INITIAL FIRE SAFETY INSPECTION REPORT

Montex Fabrics Ltd. (Extension)

RSC ID: 24561

Date: 4th October 2023

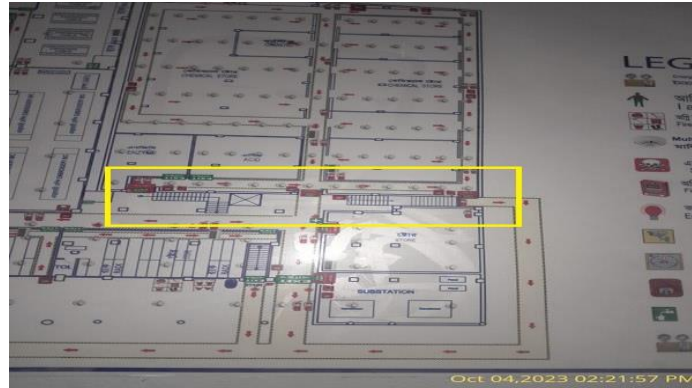
F-3	Fire Rated Construction	Two storied warehouse(chemical) building is not separated from building01(Montex fabric ltd) due to unprotected opening	Separate the two storied chemical warehouse building and building 01 is fire separated by minimum 2-hr fire rated construction.	within 3 months
-----	-------------------------	---	---	-----------------
